**Planning Application for
Minor Relaxation of Building Height Restriction to Construct a Car Park and an
Ancillary Plant Room at Basement Level for Permitted Residential Development
at No. 3 Lincoln Road,
Kowloon Tong, Kowloon
(New Kowloon Inland Lot No. 713)
(Planning Application No. A/K18/350)**

We submit herewith a set of replacement pages of the Application Form and "Response-to-Comments" in responding to the government departmental comment for the captioned planning application.

Response-to-Comments

SECTION AND CALCULATION

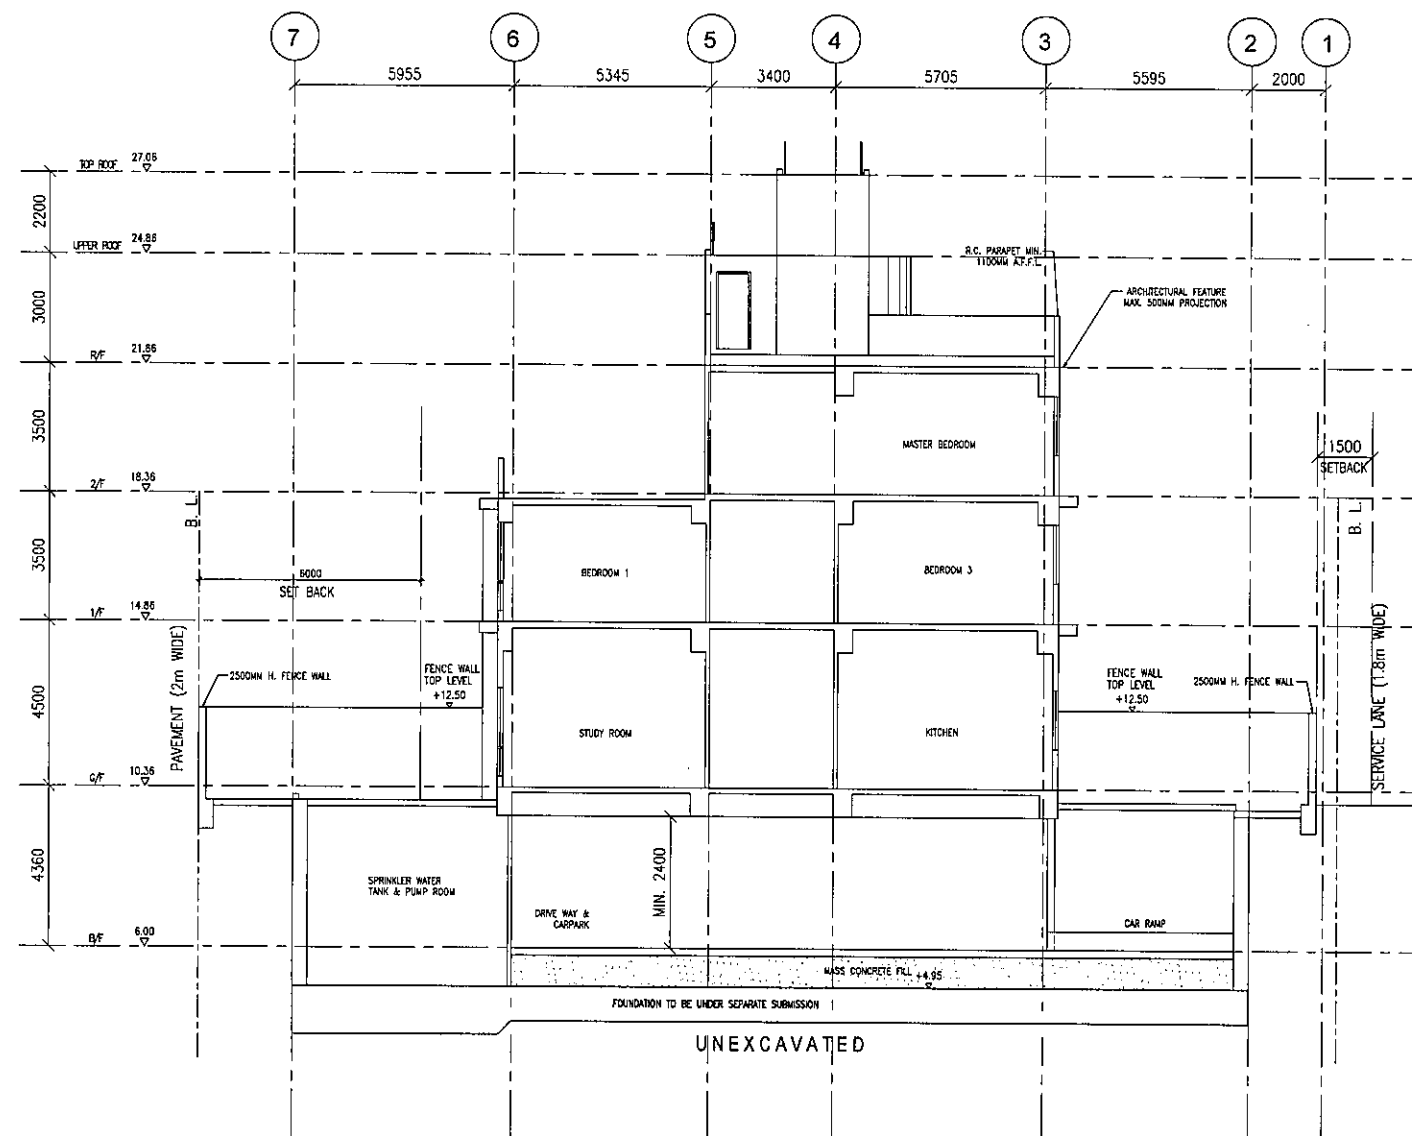
Departmental Comments	Responses
	<u>DPO/Kln, Planning Department (PlanD)</u>	
1.	It is noted that the basement size is 715m ² , which is equivalent to about 76% of the site area and about 134% of the proposed GFA, please justify and demonstrate the scale of proposed basement is not excessive.	<p>In order to meet the Commissioner of Transport's requirement, 1 no. of additional PC parking space at basement level and 1 no. of LGV L/UL bay is provided at G/F. In addition, the proposed facilities are essential to the proposed house based on the functional, building services, geotechnical and structural design requirements.</p> <p>Nevertheless, the proposed basement area is reduced from 715m² to 689.165m² for minimizing the basement size to accommodate 282.279m² of car parking spaces and manoeuvring spaces, 241.867m² of ancillary plant rooms, 129.819m² of ramp, 33.9m² lift and circulation space and 1.3m² of pipe duct.</p>

BASEMENT:		
1. CAR PARKING SPACE & MANEUVERING SPACE	=	282.279 m ²
2. CAR RAMP	=	129.819 m ²
3. ESSENTIAL PLANT ROOMS	=	241.867 m ²
4. LIFT AND CIRCULATION SPACE	=	33.900 m ²
5. PIPE DUCT	=	1.300 m ²
TOTAL BASEMENT AREA	=	689.165 m ²
G/F:		
1. INDEPENDENT STAIRCASE FOR EMERGENCY EXIT	=	15.944 m ²
2. F.S.I., ELECTRICITY METER KIOSK & POTABLE WATER METER	=	6.765 m ²
I/F:		
1. VOID	=	16.424 m ²
R/F:		
1. DOG HOUSE	=	1.625 m ²
2. STAIRCASE & LIFT SHAFT	=	24.398 m ²
TOTAL	=	754.321 m ²
